CITY OF MOUNTAIN VIEW  
MOUNTAIN VIEW, CALIFORNIA  
ADDENDUM NO. 1  
TO CONTRACT DOCUMENTS AND SPECIFICATIONS  
FOR  
FIRE STATION NO. 5, PROJECT 09-32

**CITY OF MOUNTAIN VIEW**  
**MOUNTAIN VIEW, CALIFORNIA**  
**ADDENDUM NO. 1**  
**TO CONTRACT DOCUMENTS AND SPECIFICATIONS**  
**FOR**  
**FIRE STATION NO. 5, PROJECT 09-32**

## MOUNTAIN VIEW FIRE STATION No. 5

Sketch Number: ASK-1

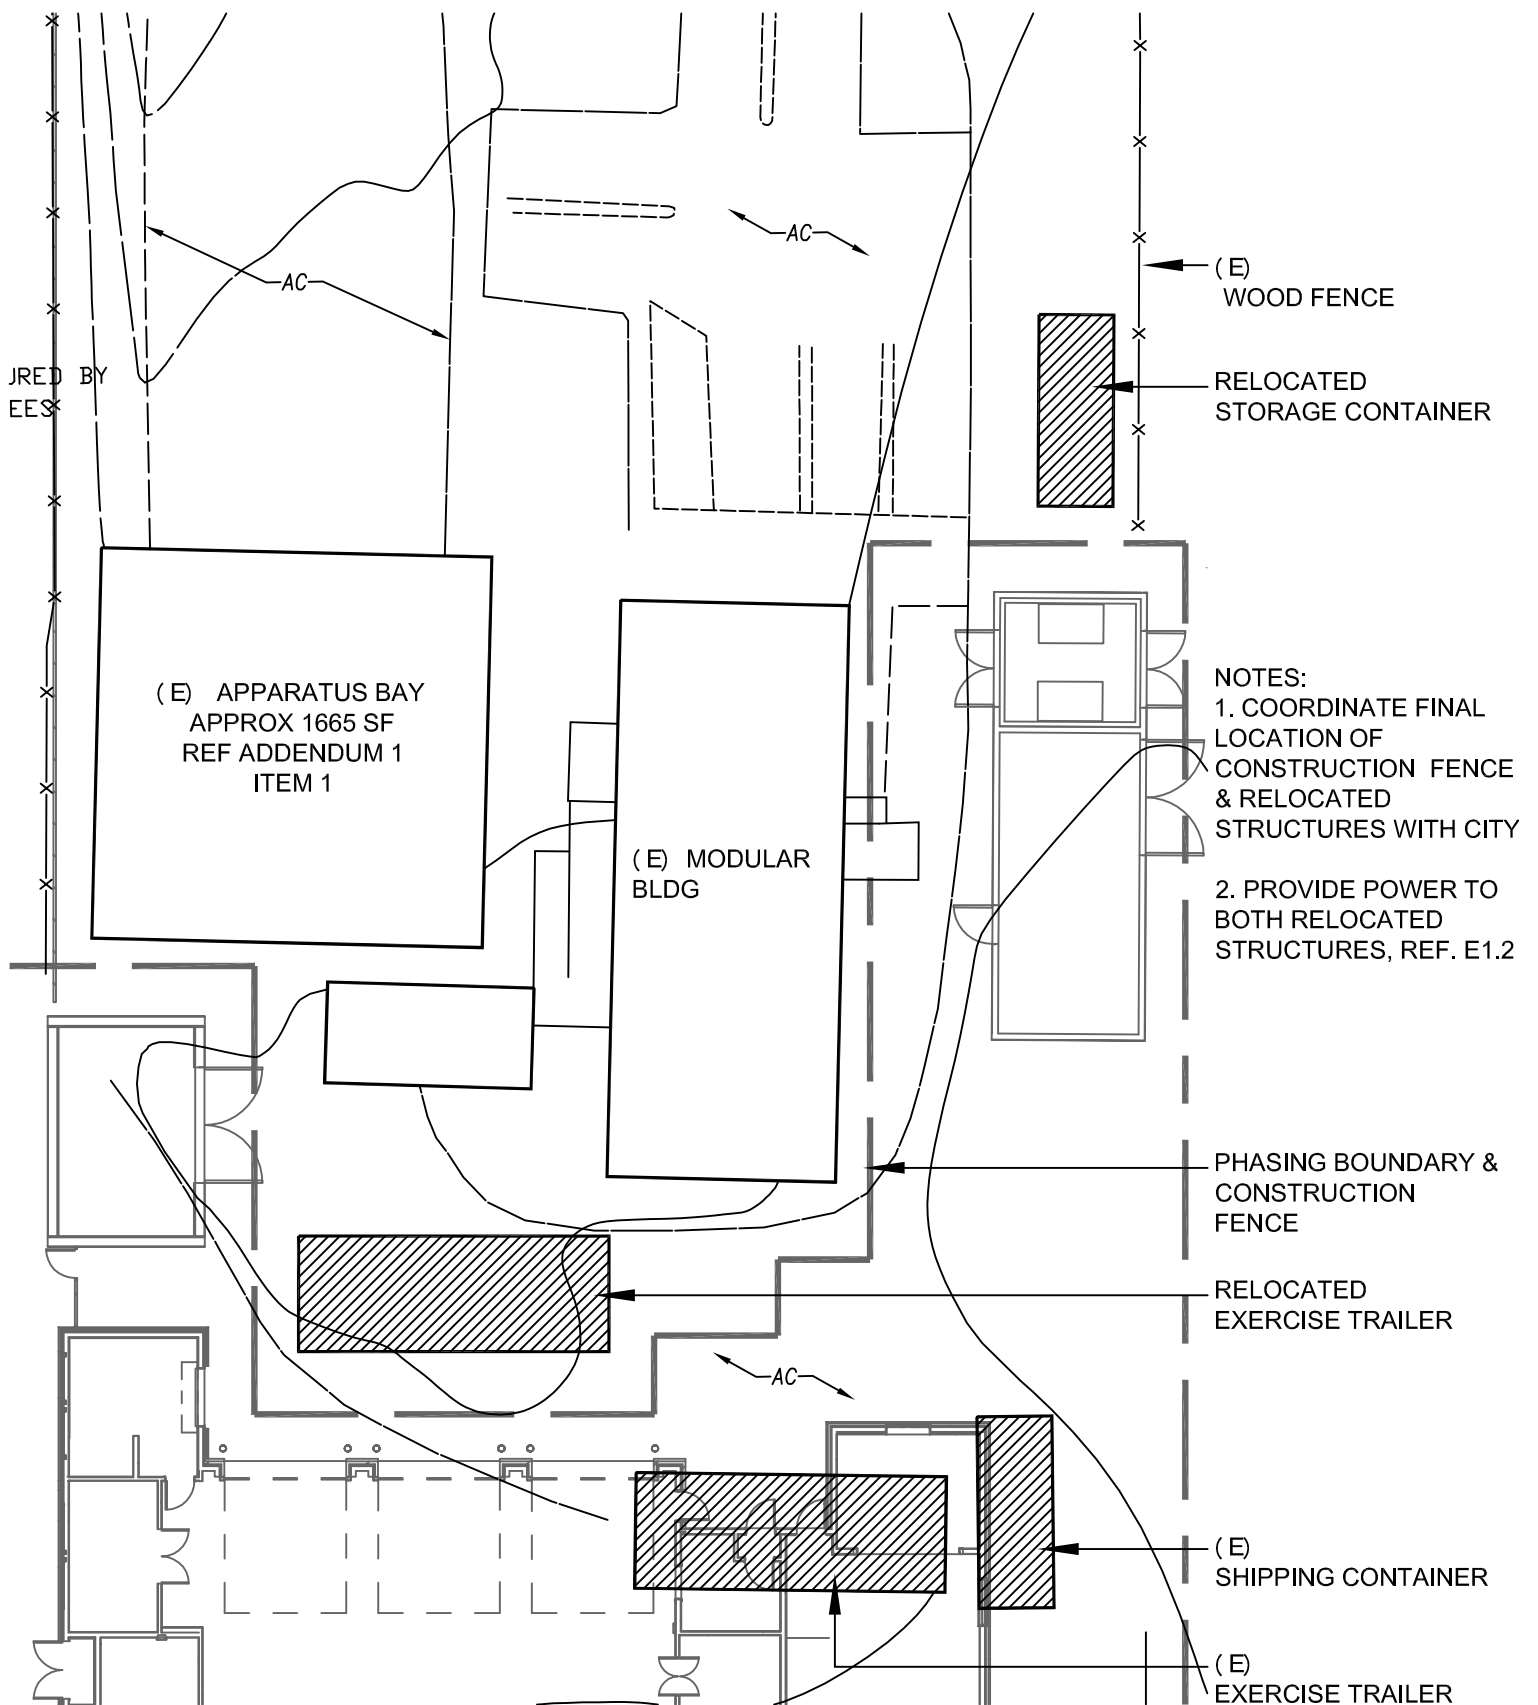
At (E) Apparatus Bay Building (refer to ASK-1)

Revise the relocation of the existing Exercise trailer as indicated on ASK-1. Relocate the existing storage container, including the attached ladder and air monitoring equipment, as indicated on the sketch. Confirm the final location of each item with the fire station personnel. Connect the trailer and the container to the power source shown on sheet E1.2. Dispose of both items in Phase 2 of the project.

ASK-2

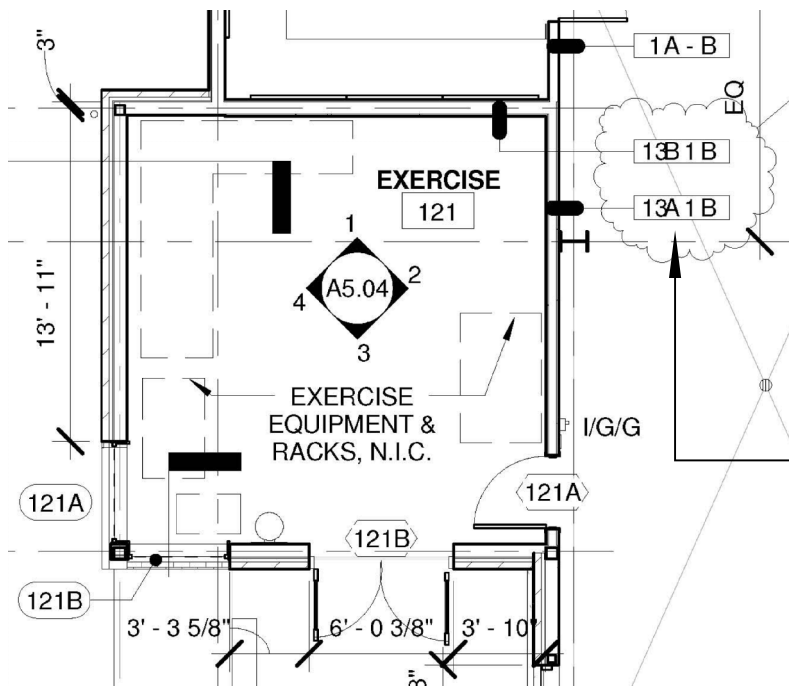
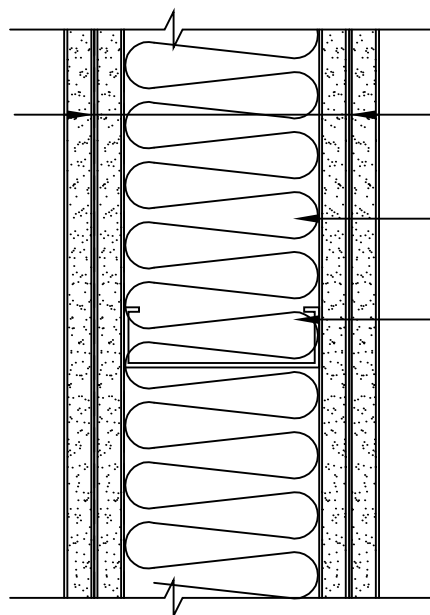
The partition references at Room 121 Exercise have been revised per ASK-2. The revised partition is a full height acoustical partition with a 1 HR fire rating, as scheduled on A9.01. Add partition type detail 13 to sheet A9.01

SHEET A2.01  
REVISE PARTITION  
REFERENCES

SHEET A9.01  
ADD PARTITION TYPE  
REFERENCED ABOVE

2 LAYER TYPE "X"  
5/8" GYP. BD.  
@ EACH SIDE

ACOUSTICAL  
BATT INSULATION

METAL STUDS  
AS SCHEDULED

FIRE RESISTANCE & ACOUSTICAL  
PERFORMANCE CONFORM TO  
GA FILE NO. WP 1522  
55 - 59 STC SOUND RATING

NOTE: 1 HR FIRE RESISTANCE IS  
REQUIRED, REF. T1.03

Issued As:  
 Sketch Number: SSK - 1  
 Date: 5/6/10

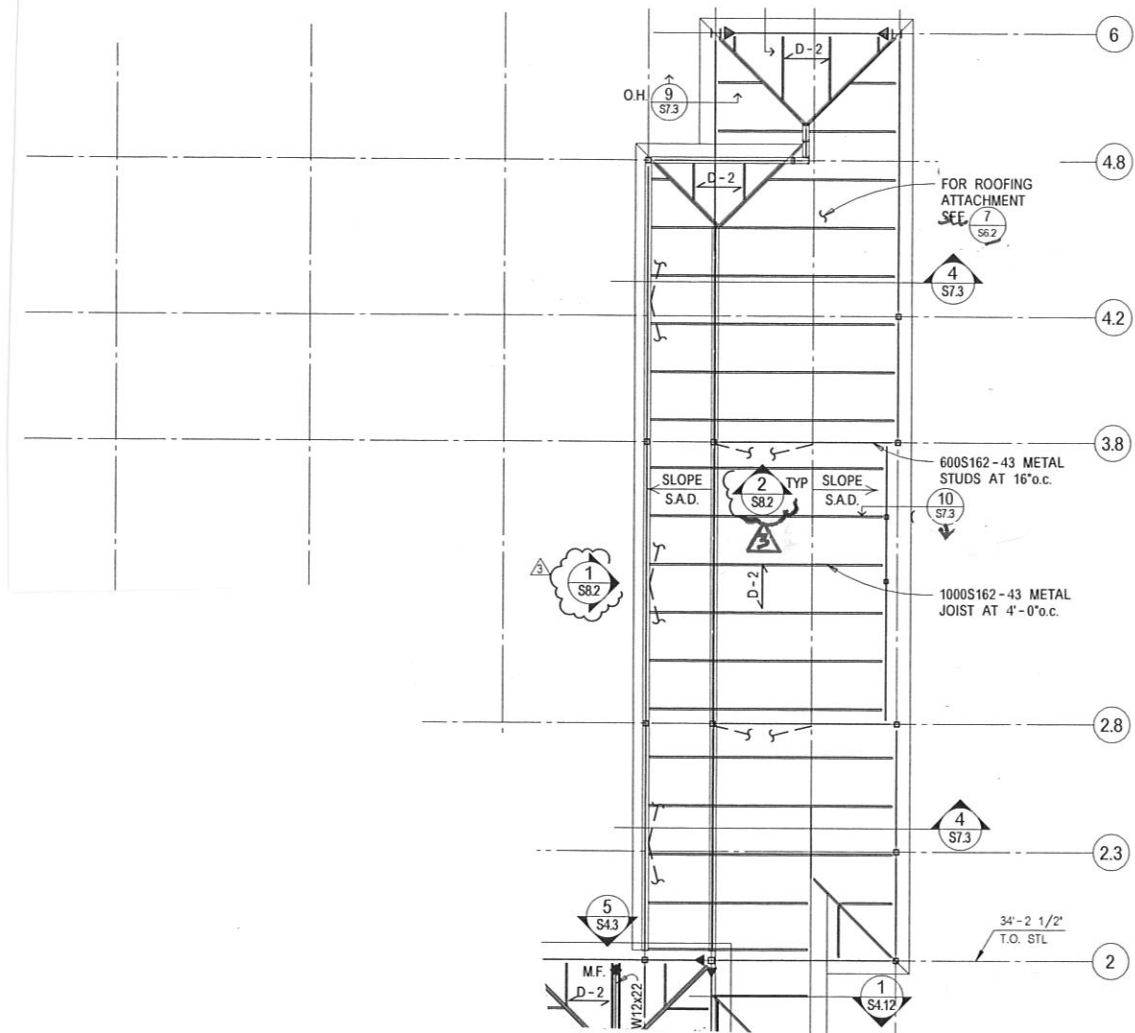
Revise Plan to include elevation call outs for diagonal strap bracing.

SSK - 2

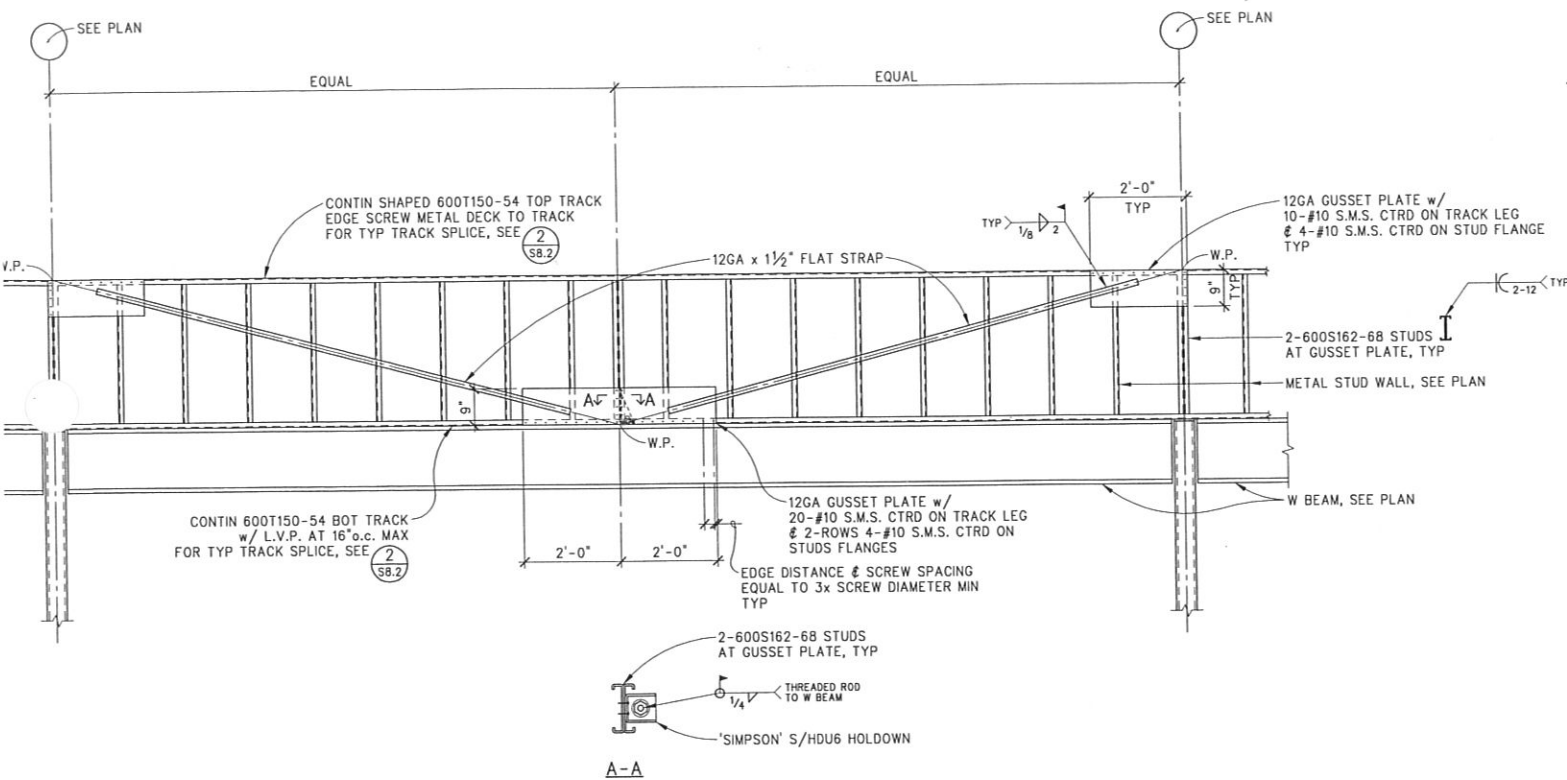
Add detail 1, Flat strap bracing elevation.

SSK - 3

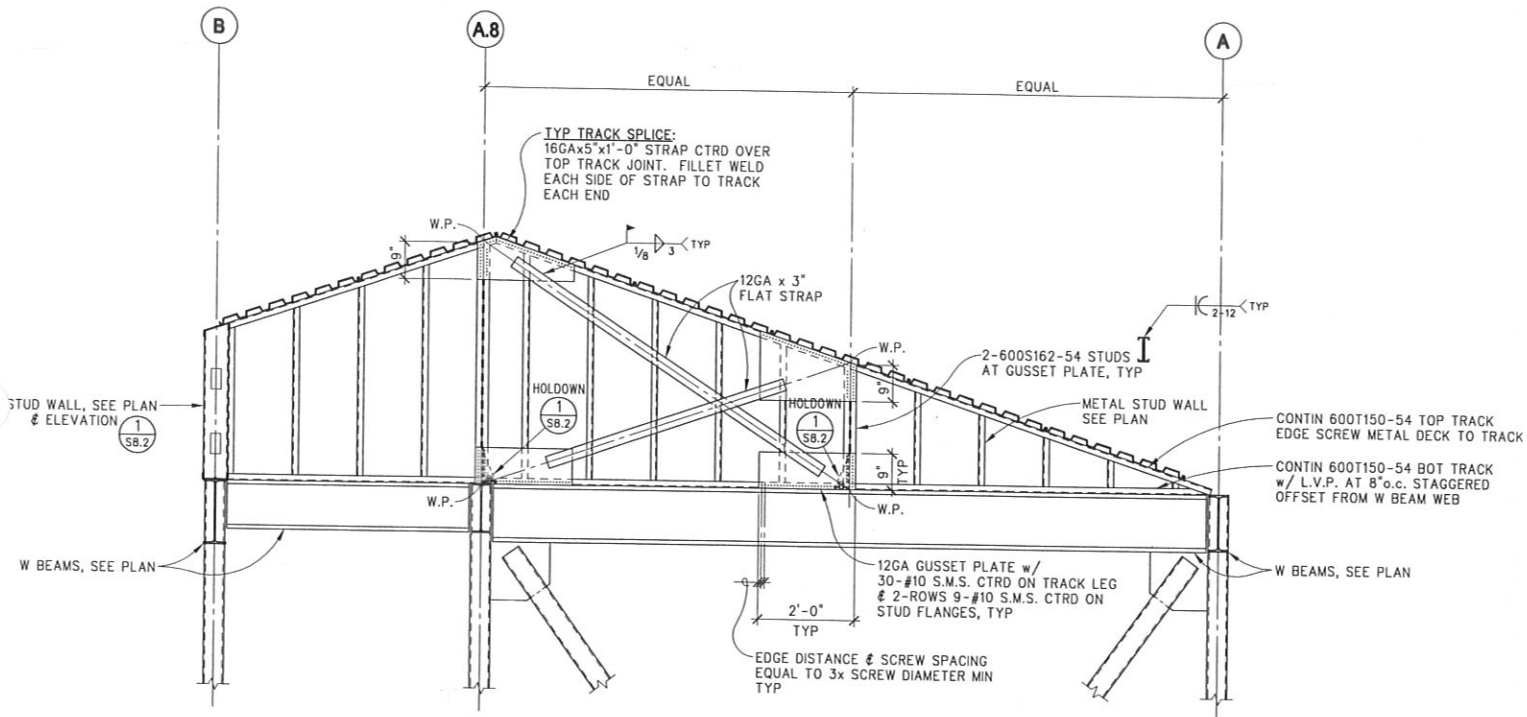
Add detail 2, Flat strap bracing elevation.

Sketch Number: #ESK-1

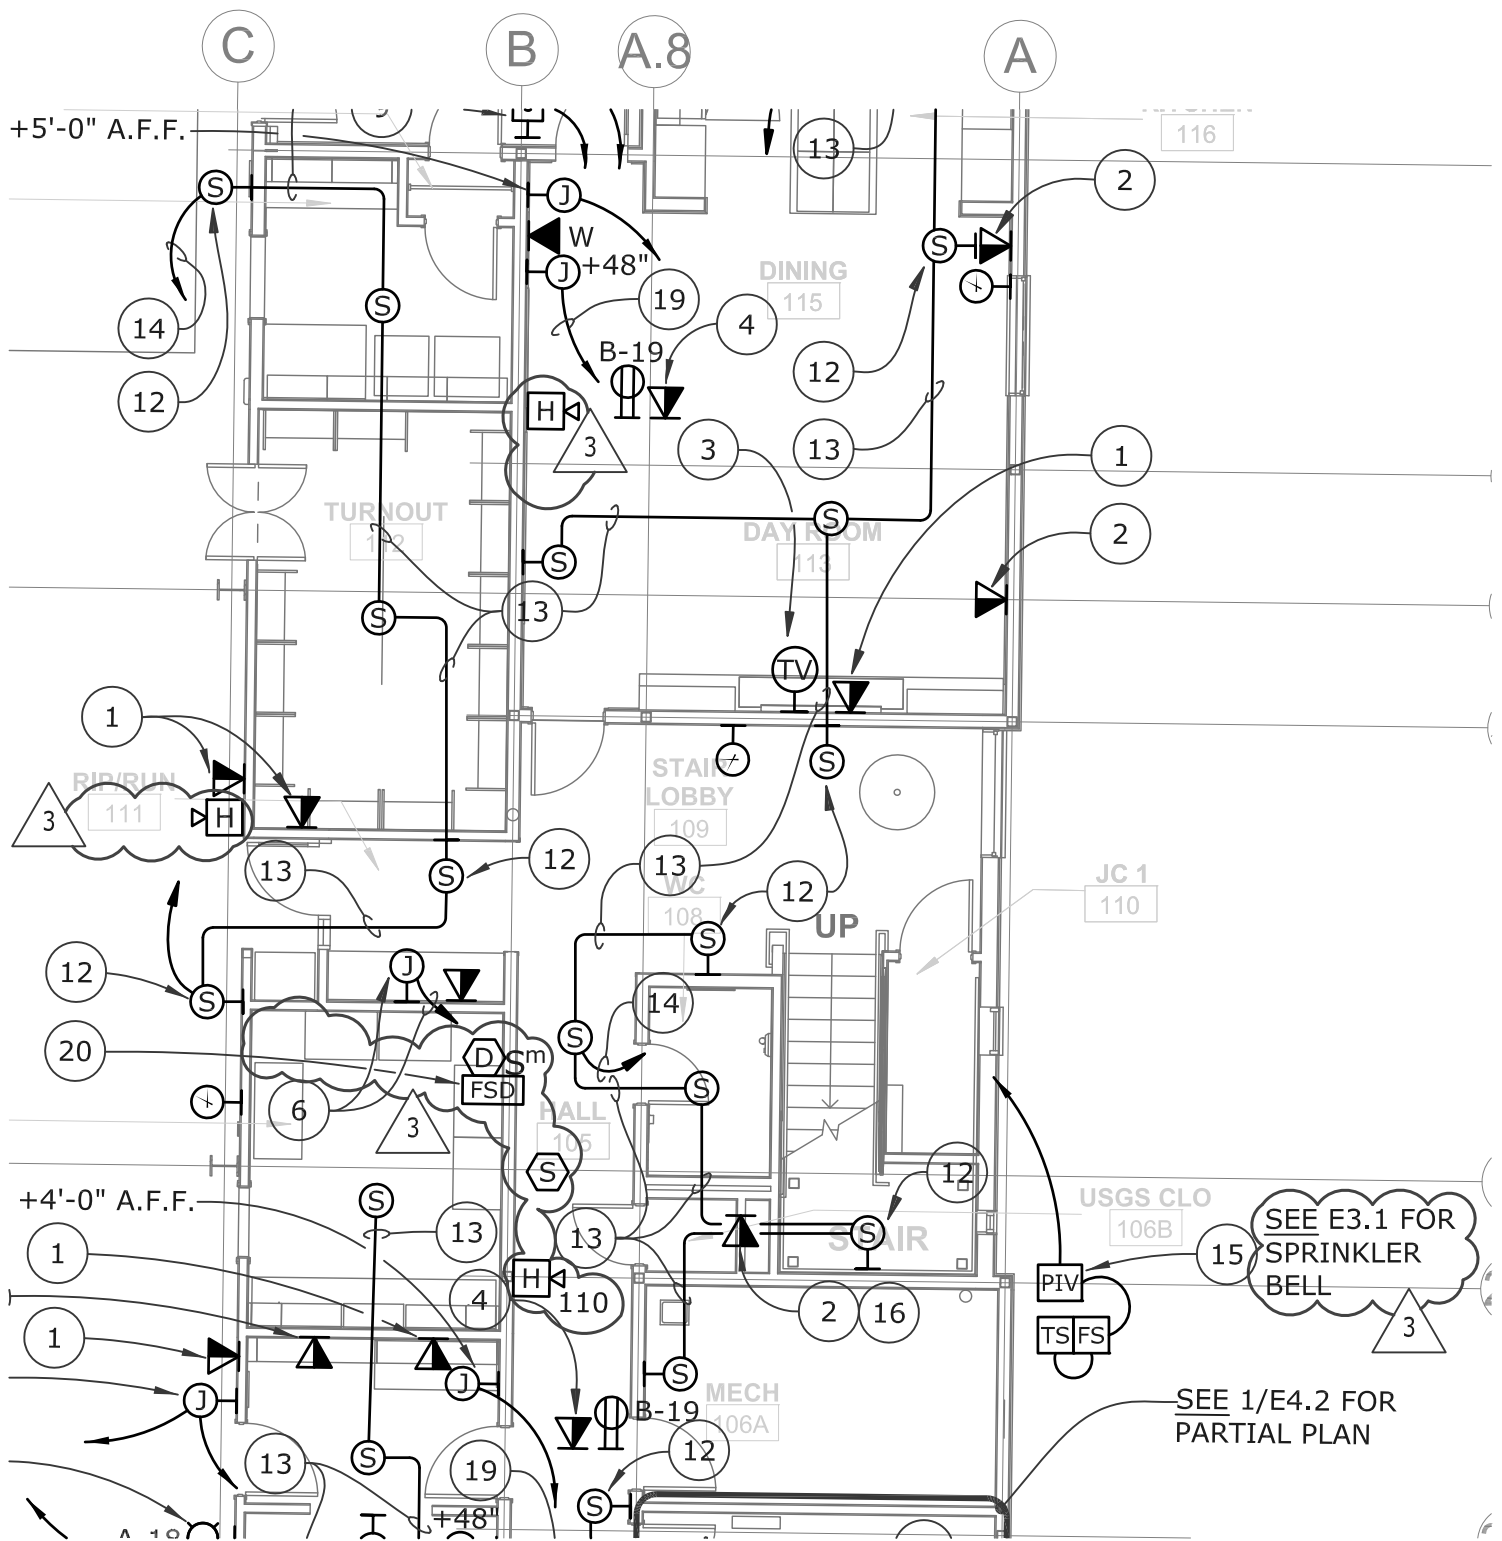
Sketch ESK-1: Revise Fire Alarm horn/strobes to horns only; relocate Fire Smoke Damper; add note regarding automatic sprinkler bell.
